FORMAL ADA/PROWAG CIVIL RIGHTS GRIEVANCE

Hawthorne/Weatherstone Neighborhood Greenway Project (2024)

Submitted to: Michael Shermis, ADA Coordinator / Human Rights Commission Director

Re: ADA/PROWAG Non-Compliance — Hawthorne/Weatherstone Neighborhood Greenway

IMS survey map: E. University Street showing "Good" ratings at and near the alley crossing (~412 E. University St.), highlighted with box.

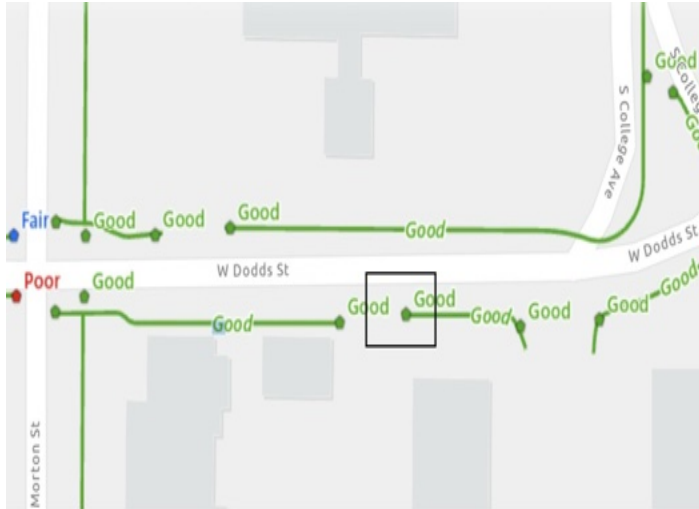
Fig. A1: City alley entrance at approximately 412 E. University Street, rated 'good' in the IMS survey. The location lacks a compliant curb ramp or blended transition.
